# SERVICE BULLETIN

<b>DATE:</b>	October 24, 1997	<b>SERVICE BULLETIN #</b>	SB-1534	<b># OF PAGES: 2</b>
<b>SUBJECT:</b>	TELESIS / FXC MODEL 12000 RESERVE ACTIVATION CHECK			
<b>STATUS:</b>	<b>RECOMMENDED</b>

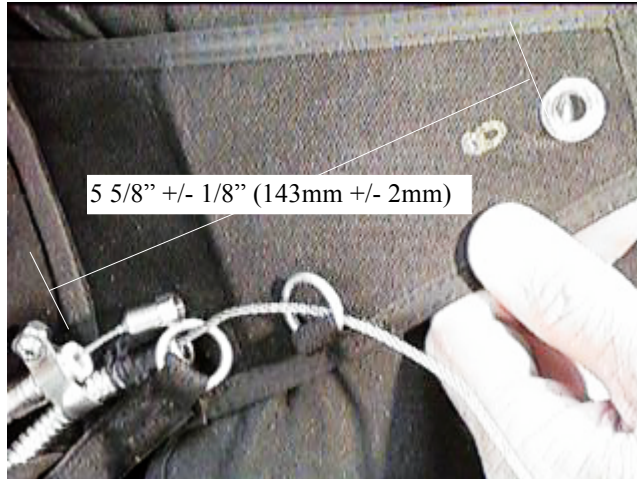
Rigs have been found to have AAD activation without extraction of the ripcord pin. Investigation found that affected rigs were packed with canopies at the upper limit of container volume such that the top reserve container flap (#1) is curved over the top of the tightly stuffed deployment bag. Activation of the AAD resulted in movement of the reserve ripcord housing and FXC power cable toward the pin. The movement effectively shortened the travel of the power cable and the movement of the pin. This bulletin recommends test activation of all FXC equipped Telesis reserves and checking of the distance from the end of the power cable to the edge of the grommet in the #1 top flap.

If pin is not extracted when unit fires, the FXC installation should be corrected to ensure that FXC power cable maintains the proper distance from the closing loop to extract the pin.

The simple modification requires the FXC power cable to be moved away from the closing loop by loosening the clamp, sliding the clamp and housing back, and retightening the clamp. Measure the straight line distance from the plastic insert end of the power cable to the nearest edge of the grommet in the #1 top flap. The distance should be 5 5/8" +/- 1/8" (143 mm +/- 2 mm). Tighten clamp securely. Ensure that clamp and power cable cannot slip by pulling hard in both directions.
